<p>Proposal #21: 1009-42-70 Regionwide Culvert Replacement Wood County Culverts Var Hwy Wood County</p>	<p>1009-42-73 Regionwide Culvert Replacement Waupaca County Culverts Var Hwy Waupaca County</p>
<p>6841-00-60, WISC 2019 229 Fremont - Appleton Wolf River Bridge B-68-31 STH 110 Waupaca County</p>

This is Addendum No. 01, which provides for the following:

Addendum No. 01
ID 6841-00-60
Revised Sheet 110
April 2, 2019

CONCRETE OVERLAY
SHEET 1 OF 7
110

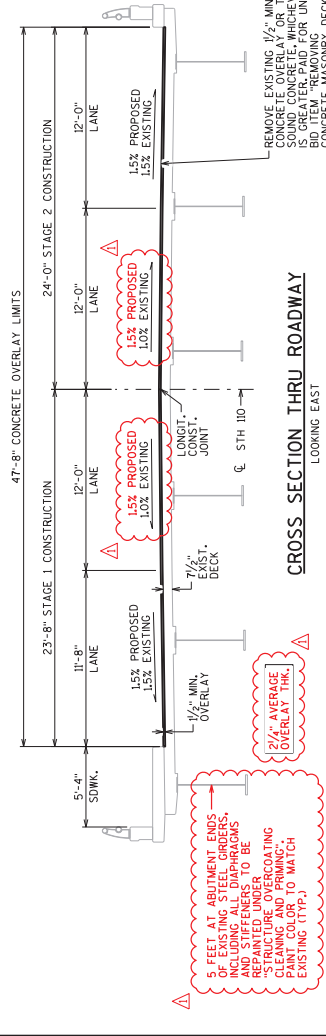
Revised Plan Sheets	
Plan Sheet	Plan Sheet Title (brief description of changes to sheet)
110	Changed painting girders at abutment ends from 3 feet to 5 feet and changed the proposed cross slope in the inside lanes from 1.0% to 1.5%.
